Overview: Production error in version 1.0 harnesses; The immobilizer wire (orange/black) is in pin position #4 instead of pin position #5. Although an effort to correct the issue was made, some quantity of harnesses did get shipped before the issue was spotted. We are advising to inspect the harness BLADE connector before attempting to install harness or program the module. This issue is not known to affect the version 2 harnesses, which require no modification.

FTI-STP1: Notas de preparación y cobertura del vehículo

FTI-STP1: Notas de instalación y configuración

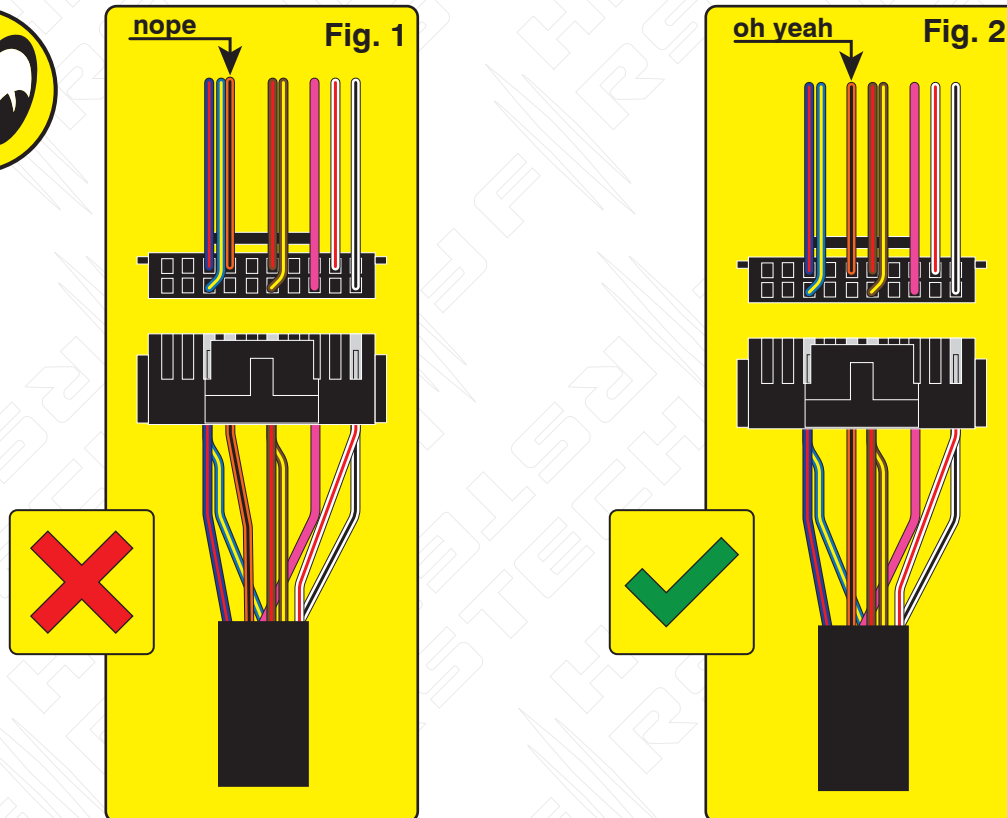
Issue: Module fails to program correctly to vehicle, does not allow the vehicle to be remote started.

Correction: Step 1.) Locate the orange/black wire and confirm whether it is positioned as illustrated in Fig. 1 or Fig. 2. If the wire is as illustrated in Fig.1, proceed with Step 2 through 5 and complete the repair procedure outlined, if the wire is as illustrated in Fig. 2, correction is not necessary, proceed with harness installation and module programming.

Step 2.) Using a pick, lightly depress the catch that secures the terminal in the housing then remove the wire and terminal from the housing.

Step 3.) Using a fine tip razor or utility knife, insert the blade beneath the terminal catch and raise it slightly, so that it can be reused to secure the terminal when reinserted into the BLADE connector housing.

Step 4.) Refer to Fig. 2 for correct position of the orange/black wire (next to brown/red) then reinsert the terminal, pressing lightly until the catch 'snaps' into place, securing the terminal in the connector housing.

MODIFICACIÓN REQUERIDA PARA APLICACIONES A/T, SÓLO CON ARNÉS v 1.0

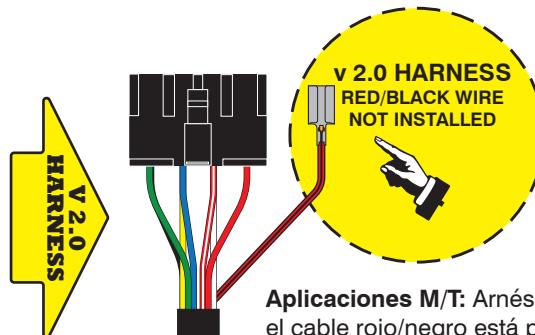
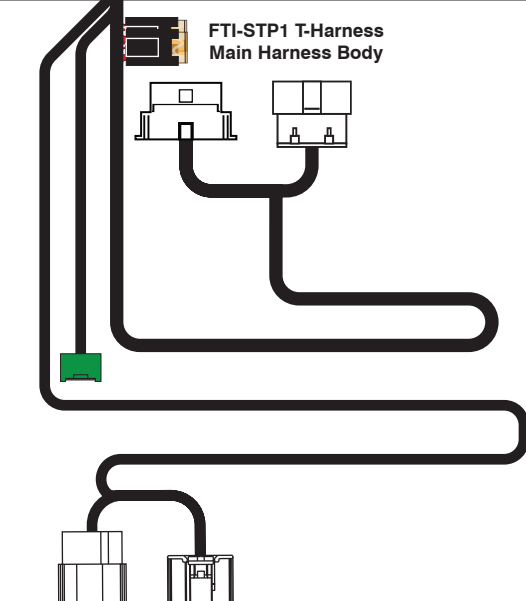
Descripción general: Las primeras versiones del arnés FTI-STP1 requieren modificaciones para aplicaciones de transmisión automática (AT), algunas del producto se pudo modificar antes del lanzamiento, pero una pequeña cantidad se lanzó sin modificaciones.

Problema: El arnés en T FTI-STP1 ha sido diseñado para ser compatible con A/T (transmisión automática) y M/T (manual), pero debido a un descuido en las primeras ejecuciones de producción, la selección se estableció por defecto en el modo M/T.

El uso de un arnés configurado para una aplicación M/T, en un vehículo equipado con A/T, podría provocar daños en el módulo del vehículo, se recomienda que el arnés vuelva al modo A/T antes de la instalación en vehículos equipados con transmisión automática.

Corrección: Localice el cable rojo/negro (+ embrague) proporcionado en el conector CN1 del conjunto del arnés principal. Corte el cable rojo/negro, ya sea al ras del conector CN1 o dejando suficiente cable expuesto para que pueda aislar y asegure los extremos del cable que quedan después del corte. Aísle cada uno de los extremos restantes del cable rojo/negro y asegúrelos para evitar cualquier posibilidad de cortocircuito. Si el cable rojo/negro ya ha sido desconectado, ninguna modificación adicional se requiere para aplicaciones A/T

NO SE REQUIERE MODIFICACIÓN CUANDO SE UTILIZA FTI-STP1 (v 1.0) ARNÉS EN APLICACIONES M/T, O CUANDO UTILICE EL ARNÉS FTI-STP1 (v 2.0)

Aplicaciones M/T: Arnés versión 2.0, el cable rojo/negro está pegado al arnés principal cuando se envía, y debe instalarse en el CN1 conector cuando está instalado.

Aplicaciones A/T: Deje el cable rojo/negro pegado al arnés, no es necesario para aplicaciones A/T
